ERRATA

MCZ-1/05 HARDWARE USER'S MANUAL

FIGURE 8: MCZ CONNECTOR PLACEMENT

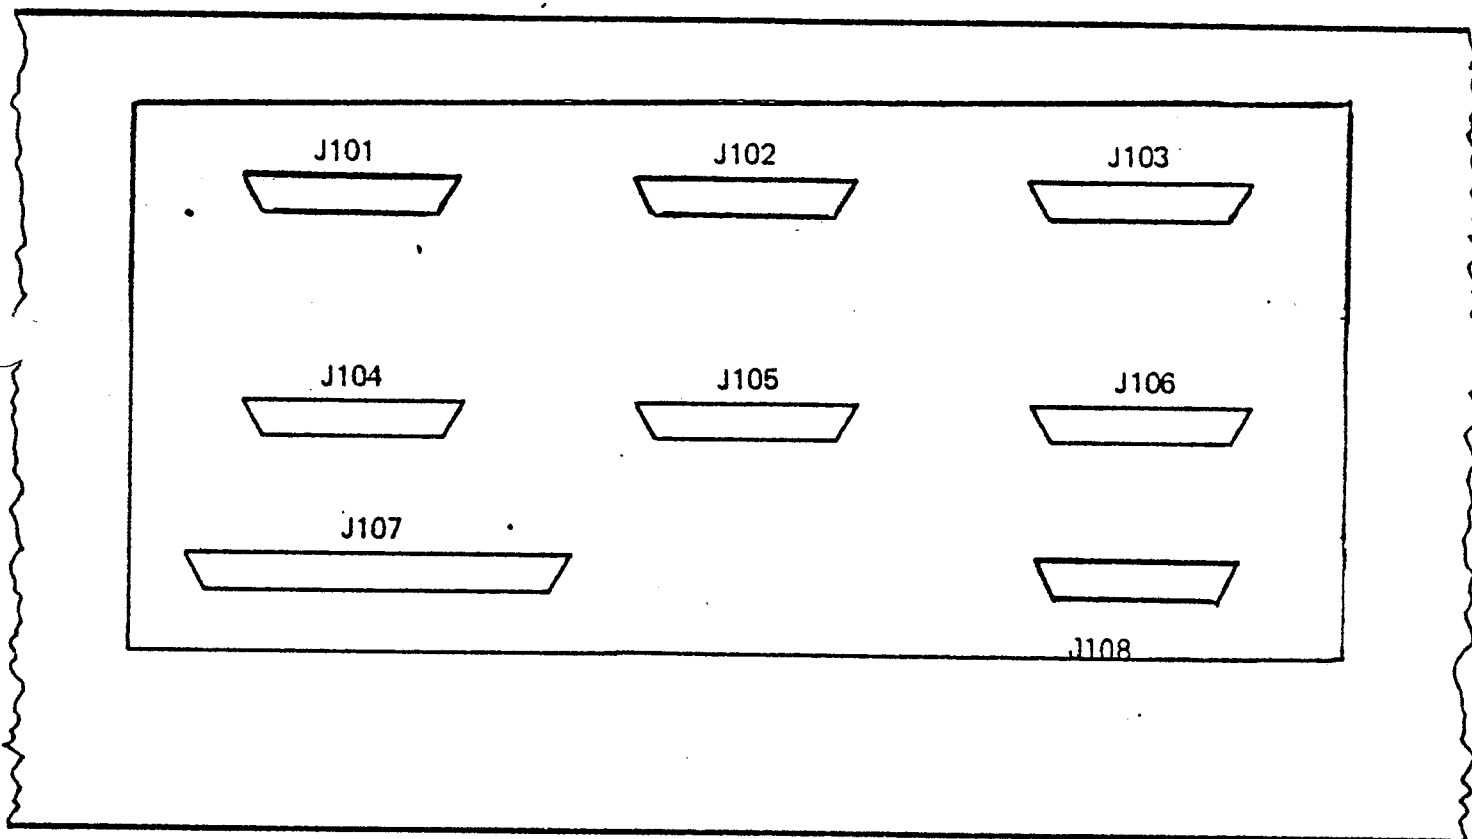
1. Page 8: Figure 3 delete PDS designation
2. Page 19 : Figure 8 should appear as follows:
